## SERVICE INFORMATION

**YS-051-08**

**Subject: Pressure Switches YP9C, YM9M, TG9S & GG9S**

Figure 7 – Proper connection for blower deck penetration

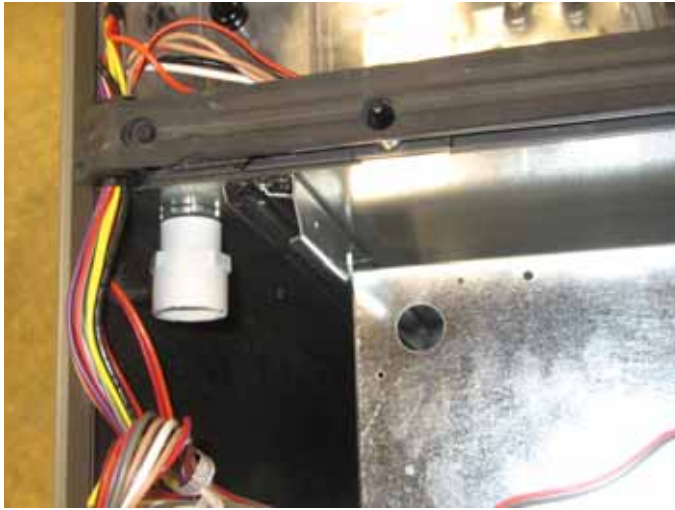
- 10) Do not make any penetrations through the blower deck. During the cool-down of the furnace the combustion blower will shut down and the circulating blower will continue to run. During this time, the negative pressure from the circulating blower can pull moist air back through the vent system and pressure switch tubing by way of the pressure switch bleed hole. The only time penetrating the blower deck is allowed is for the drain hose provided it is properly sealed using the factory provided right-angle hose fitting and O-ring (see Figures 6 and 7). All other wiring or accessory connections should be made through the sides or back of the casing. This also prevents any water that could be on the blower deck from following the path of the wires directly to the control board or any other electrical components.
